NUMBER: 79-3

DATE: 1/15/79

- A. Maximum Advance Timing Procedure and Throttle Cable Adjustment - 1979 Merc 7.5 and 9.8
- B. Stiff Throttle Operation - 1979 Merc 7.5 and 9.8
- C. Throttle Cable Chafing - 1979 Merc 7.5 and 9.8

**Figure 2. Throttle/Timing Linkage**

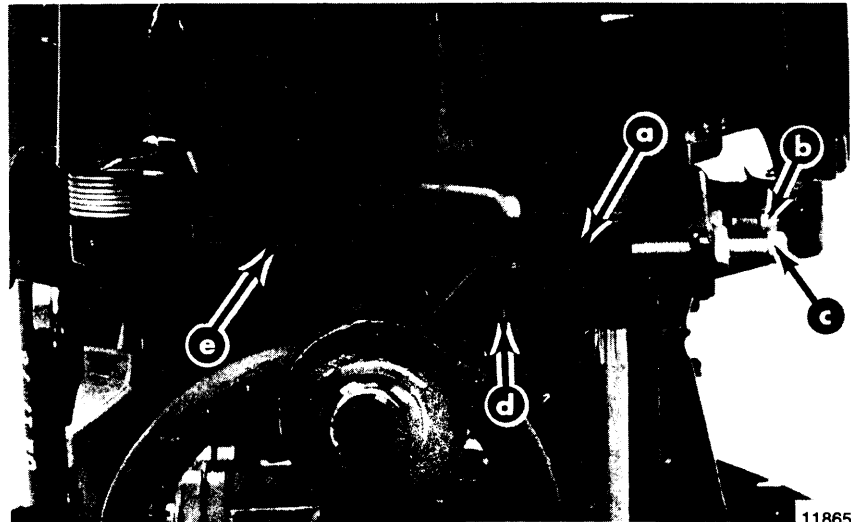
3. Loosen cable jam nuts on both throttle cables. (Figure 1)
4. Move throttle control lever (Figure 2) to align timing mark (straight line) on trigger assembly with timing mark (straight line) on end cap flange. (Figure 3)
5. With timing marks aligned (Step 4), adjust maximum advance screw (Figure 2) to just contact the throttle control lever.

Figure 4. Throttle Cam (Top View)

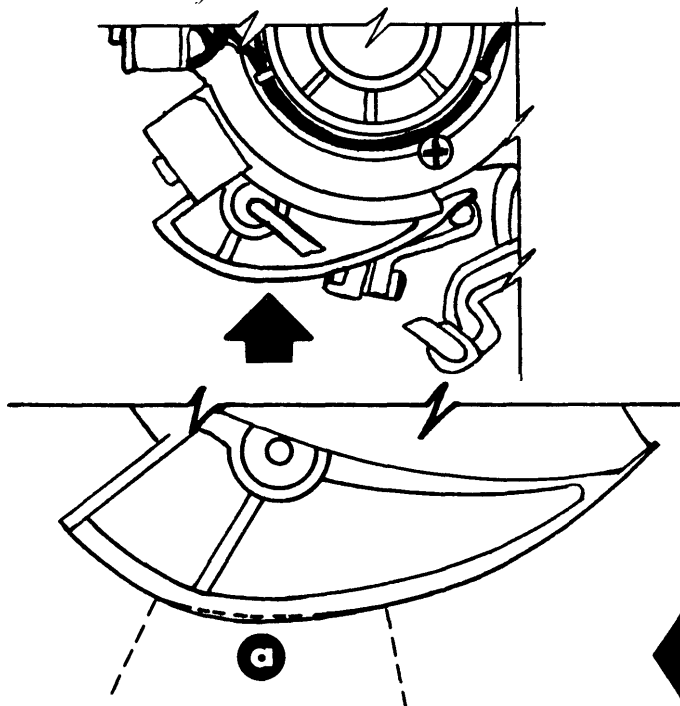
Investigation has revealed that a slight irregularity in the throttle cam may cause the throttle lever “post” to “hang up” on the cam at approximately  $\frac{3}{4}$  throttle. (Figures 2 and 4) This condition, however, usually has been noticed when checking a motor that IS NOT RUNNING (static).

**IMPORTANT:** If the above measures do not alleviate the problem, it will be necessary to remove the trigger assembly from the engine and sand or file the "high end" of the throttle cam face (from approximately  $\frac{3}{4}$  throttle position to full throttle position) to smooth-out any irregularity in the cam. (Figure 4)

1. Coat the throttle cam (Figures 2 and 4) with a light film of Special Lubricant 101 (C-92-79214) or Multipurpose Lubricant (C-92-75605).
2. Lubricate the cable (core wire) groove in the throttle spool (Figure 1) with Special Lubricant 101 or Multipurpose Lubricant and also place a few drops of light oil around the spool stub (underside of spool) where it fits into the bottom cowl.
3. Make certain that the throttle cables are properly adjusted (refer to Part "A" of this Service Bulletin).

Ignition timing **MUST BE RESET** to specification after reinstallation of the trigger assembly (refer to Part "A" of this Service Bulletin).
